Independent Market Operator

Rule Change Notice

**Title: Removal of DDAP Uplift
when less than facility
min gen**

Ref: RC_2010_08

Figure 1.

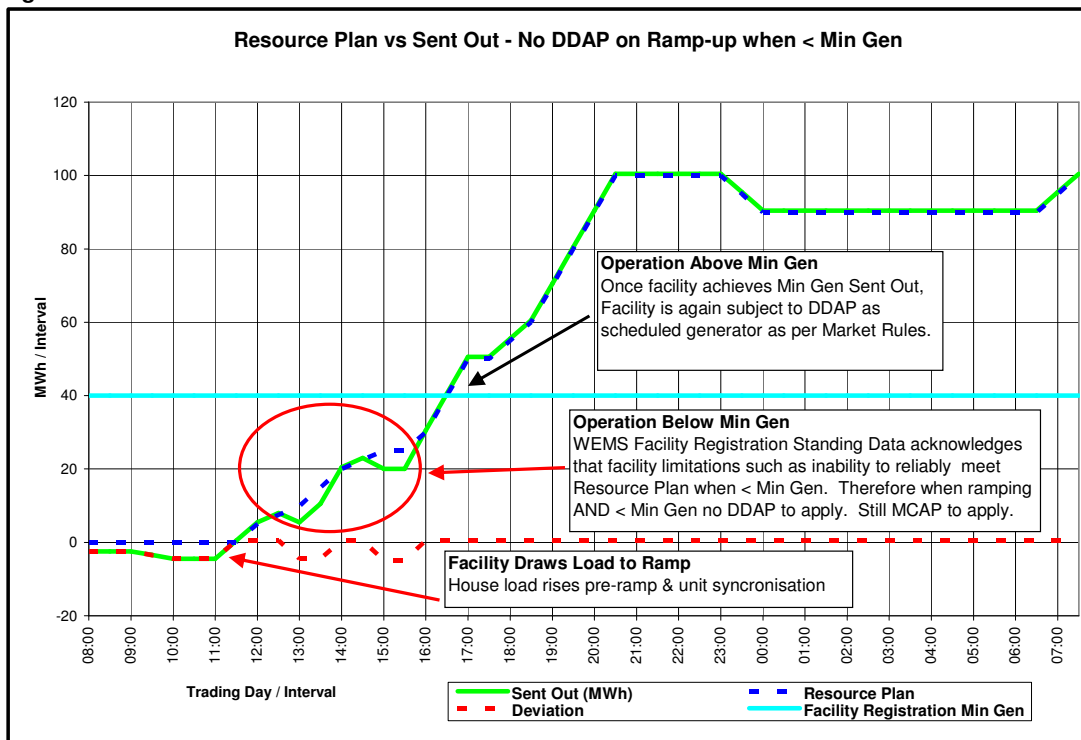
A facility will only be operating below its registered minimum generation under a Resource Plan when ramping up to a level above the minimum, ramping down to zero; or when under a forced outage affecting its entire capacity. Imposing DDAP in instances where a facility is ramping up (or down) according to a Resource Plan, in the intervals when the Resource Plan is less than the facility's registered minimum generation, imposes an additional cost on the scheduled generator above the MCAP price levied on the difference between the Resource Plan and the actual generation. In other words, the DDAP penalty is an attempt to incentivise an outcome which the generator is unlikely to be able to control. Applying DDAP to a facility that has

The ramp-up profile in Figure 1 provides an example of how this rule would be applied during a downward deviation during ramp up and ramp down. Figure 2 provides an example of how it would be applied to forced outages:

Figure 2.

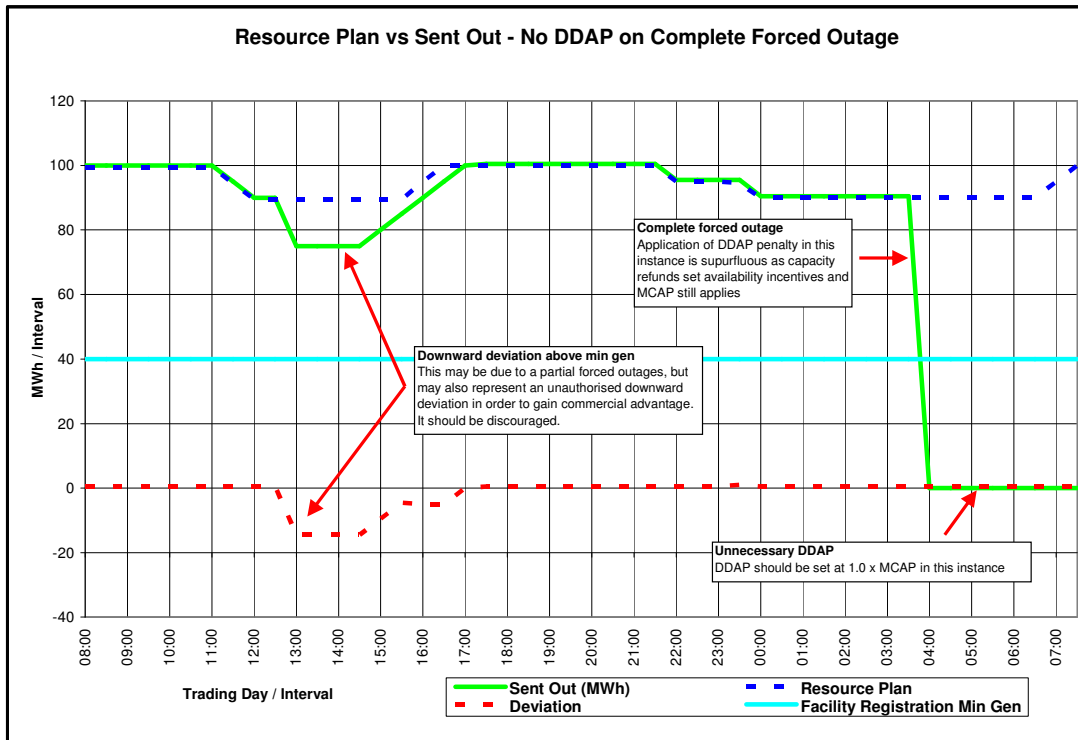
experienced a complete forced outage imposes an additional cost on the scheduled generator above the MCAP price as well as the cost of capacity refunds – which act as the specific market incentive to maintain available capacity. In other words, the DDAP penalty in this instance is superfluous.
